## Detailed Site Plan

## DSP-06003-01

STAFF REPORT

SUBJECT: Detailed Site Plan DSP-06003-01  
Type 2 Tree Conservation Plan TCP2-032-12  
New Born Church of God

# SITE PLAN (LOT 156)

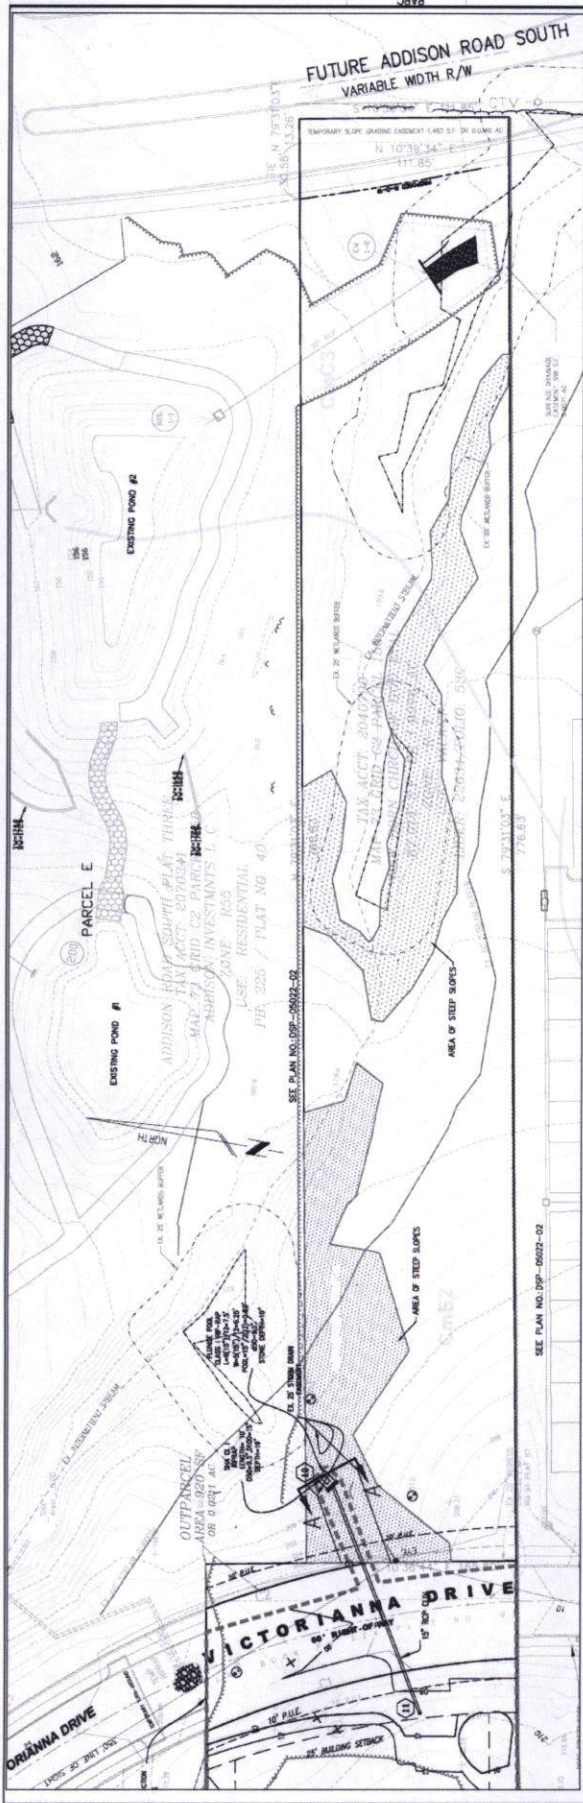
The plan shows an outfall extending from the east side of Lot 1, across Victorianna Drive, and onto Lot 156; however, there is no associated stormwater management facility or stormdrain for the outfall. Remove the outfall and associated clearing from the plan or show the proposed stormwater management facility for the outfall. Show the soils table on the plan. The plan shows a table labeled "Specimen Tree Chart"; however, the table does not provide any information regarding specimen trees. Show the specimen tree table in accordance with the ETM.

- h. Remove the symbol for woodland clearing.
  - i. Show the north arrow on both sheets outside of the plan area.
  - j. Remove the proposed outfall and associated clearing from the plan or show the proposed stormwater management facility for the outfall.
